Product Change Notification

Change Notification #: 106485 - 00
Change Title: Desktop Intel® Pentium® 4, Pentium® D and Intel® Celeron® D Processors, PCN 106485-00, Product Marking, Wrapping of the Lot Number
Date of Publication: July 17, 2006

Product Marking

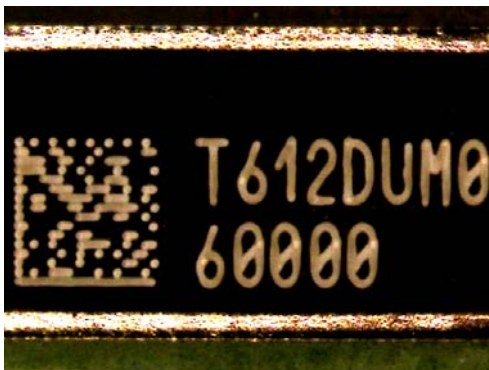
To ensure that the ATPO marking fits onto the ink swatch within the IHS lid notch, the number will be wrapped after the 7th character/digit onto the second line and followed by the serial number as a result of improving the Unit Level Traceability (ULT) mark placement.
